Access Compliance Report

Public Rights-of-Way

Intersection ID: 10038086	Main Street: SIKES_PL	Cross Street: N/A	Location: E
ADA ID: FF642AD5D94F	Ramp Type: BlendTrans1	Initial Pass/Fail: Fail	Overall Compliance: No
		Severity Score: 8.75

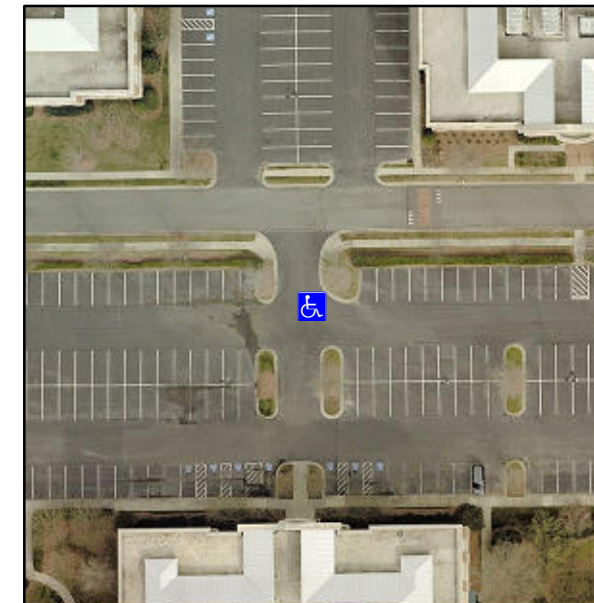
Not Found, R304.5.1

Compliance	Description	Data	Compliance	Description	Data
N/A	Ramp Length (in)	47.0	Yes	BlendTrans Slope (%)	4.0
No	Ramp Width (in)	45.0	Yes	BlendTrans XSlope (%)	1.3
N/A	Flare Type LT	N/A	N/A	Flare Type RT	N/A
N/A	Flare Slope LT (%)	N/A	N/A	Flare Slope RT (%)	N/A
N/A	Flare Traversable LT?	N/A	N/A	Flare Traversable RT?	N/A
N/A	Landing Length (in)	N/A	N/A	DWS Provided?	N/A
N/A	Landing Width (in)	N/A	N/A	DWS Contrast?	N/A
N/A	Landing Slope (%)	N/A	N/A	DWS Length (in)	N/A
N/A	Landing X Slope (%)	N/A	N/A	DWS Full Width?	N/A
N/A	Landing Curb? (Y/N)	N/A	N/A	DWS Offset (in)	N/A
N/A	Shared Landing?	N/A			
N/A	Gutter Ponding?	N/A	N/A	Gutter Slope (%)	N/A
N/A	Gutter Lip Ht (in)	N/A	N/A	Gutter X Slope (%)	N/A
N/A	Painted X Walk1?	No	N/A	Painted X Walk2?	No
	X Walk 1 Direction	To N		X Walk 2 Direction	To W
	X Walk 1 Width (in)	N/A		X Walk 2 Width (in)	N/A
	X Walk 1 Slope (%)	2.1		X Walk 2 Slope (%)	0.8
	X Walk 1 X Slope (%)	2.1		X Walk 2 X Slope (%)	6.1

N/A	Ramp inside XWalk1?	N/A	N/A	Ramp inside XWalk2?	N/A
	Road Slope (%)	1.9		Clear Space?	N/A
	Road X Slope (%)	3.1	N/A	Clear Space to XWalk (in)	N/A
N/A	Any Obstructions?	N/A	N/A	Storm Grate/Utility Hazard?	N/A
	Obstruction Type			Storm Grate/Utility Type	
		N/A			N/A
			Yes	Surface Condition? (G/P)	Good
			No	Curb Slope (%)	8.3

Remove & Replace Curb Ramp With Two New Directional Ramps or Equivalent.
